PW Review

Generator Storage Structure

PERMIT SET

City of Marco Island South Water Treatment Plant

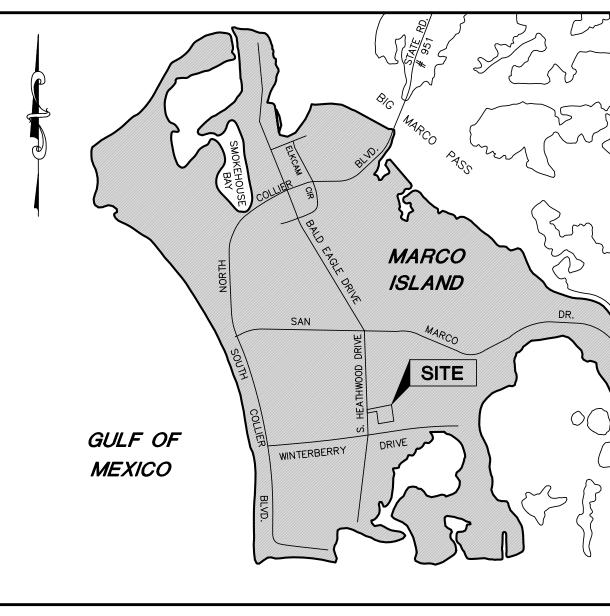
A Stormwater Pollution Prevention Plan (SWPPP) must be submitted prior to land disturbance and must comply with F.A.C. 62-621.300(4) and the NPDES Construction General Permit (CGP) if more than one acre of soil will be disturbed. An Erosion and Sediment Control Plan, prepared by a licensed professional engineer, must be included as part of the permit submittal. It shall demonstrate compliance with the Florida Department of Environmental Protection's BMP Manual (most current edition).

The applicant is responsible for ensuring that BMPs are implemented, maintained, and adjusted in the field as needed to prevent pollutant discharge and protect adjacent properties and water bodies. zluff, 07/27/2025, 1:00:43 AM
